SAFETY RECALL

SR25-311

DATE :	November 2025	SECTION :	23 ACCESSORIES
SUBJECT:	WALL MOUNTED RETRACTABLE SHOULDER BELT REINSTALLATION

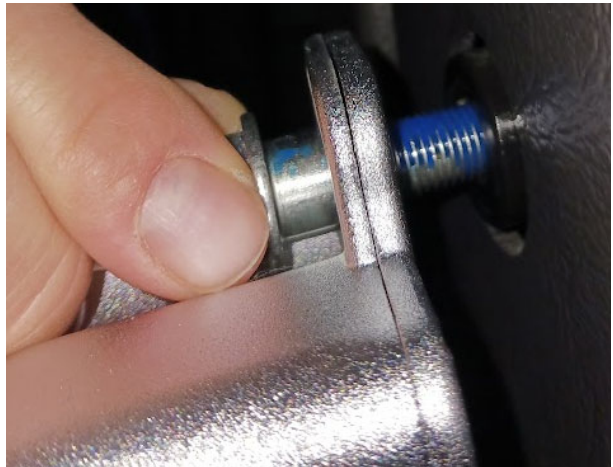
1. Loosen the shoulder belt and remove the bolt.

2. Remove the nylon washer and discard.

3. Remove scotch grip on the bolt. Use a wire brush to help. Clean the finishing surface.

4. When the bolt is clean, put blue loctite 680038 on it.

5. Cut a length 3.5inches of tape 506001
6. Put a the protection tape 506001 on the back of the belt.

7. Torque the bolt with a **17mm** socket. The torque needs to be with set at **27lbs-ft**.

8. **Note :** If the belt touches the finishing surface of the post and is tight. The use of 1 or 2 500897 washers can be necessary. It will shift the shoulder away from the finishing surface.

9. Test the belt. It needs to rotate freely.
